EAGLE RIVER

I. Introduction

The draft total maximum daily loads (TMDLs) for copper, lead, silver, ammonia, and chlorine in the Eagle River near Eagle River, Alaska, were developed in conjunction with the National Pollutant Discharge Elimination System (NPDES) permit for the Municipality of Anchorage (MOA), Eagle River Wastewater Treatment Facility (WTF). The draft TMDLs were included in the fact sheet for the permit and the public comment period was concurrent with the comment period for the draft permit (September 14, 1994, to October 14, 1994). Comments on the draft permit were received from the MOA, two of which are relevant to the TMDLs for metals. These comments were considered by EPA in establishing the final TMDLs. No comments were received on the TMDLs for chlorine or ammonia: therefore, the final TMDLs for those pollutants remain unchanged. For silver, information received from the MOA indicated that the discharge from the Eagle River WTF does not have the reasonable potential to cause or contribute to an exceedance of the water quality criterion for silver. In addition, there are no data to indicate that the Eagle River exceeds the criterion for silver, nor is there any

FIGURE 1
FLOW vs LN HARDNESS
LN HARDNESS = 4.690 - .0006 * FLOW
flow = 42 cfs
Ln Hardness = 4.58
Flow = 205 cfs
Ln Hardness = 4.49
LN_HARDNESS
5
4.8
4.6
4.4
4.2
4
3.8
3.6
3.4
FLOW
0
200
400
600
800
1000
1200
1400
1600
1800

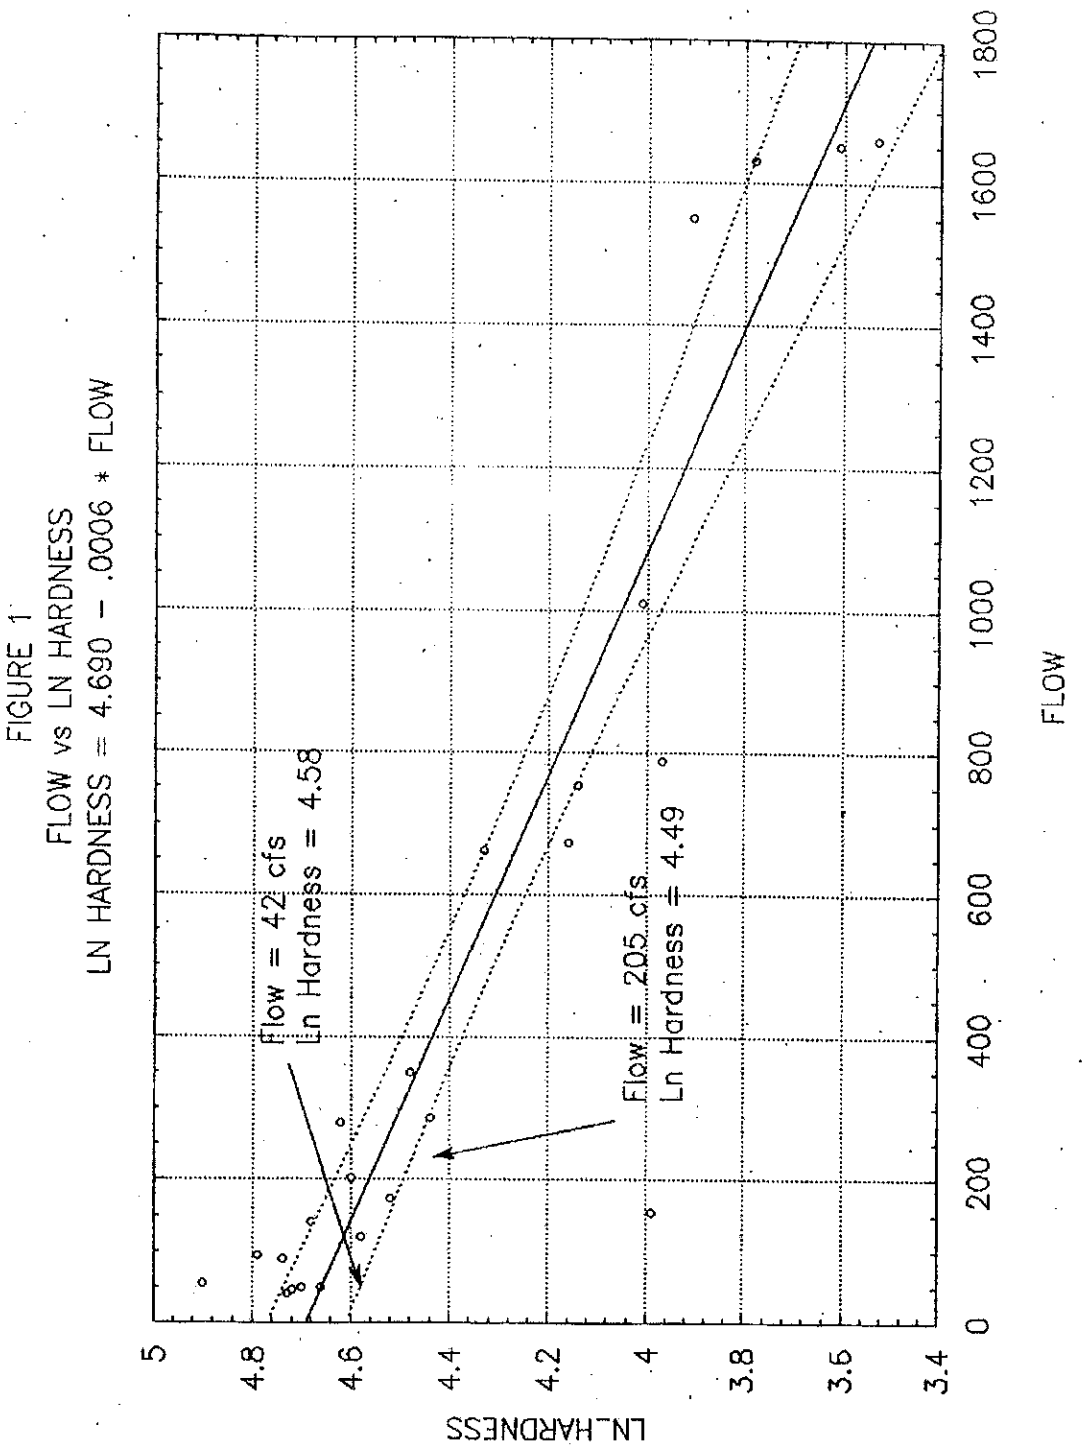
2. **Comment:** The MOA commented that the hardness values used to calculate the metals criteria were too low. They proposed three alternatives for establishing the appropriate hardness with which to calculate the metals criteria: 1) using the average hardness, 2) basing compliance on the actual hardness measured at the time of sampling for metals, or 3) using the correlation between the natural log (ln) of the hardness and flow to determine a fifth percentile hardness for the summer and winter flows.

Response: While EPA does not support the first two proposals, the third proposal, using the correlation between hardness and flow, is acceptable.

As discussed in section III. of this document, EPA considers the third proposal to be basically sound. The fifth percentile hardness correlated with the seasonal 7Q10 flows was used to determine the appropriate metals criteria upon which the TMDLs were based.
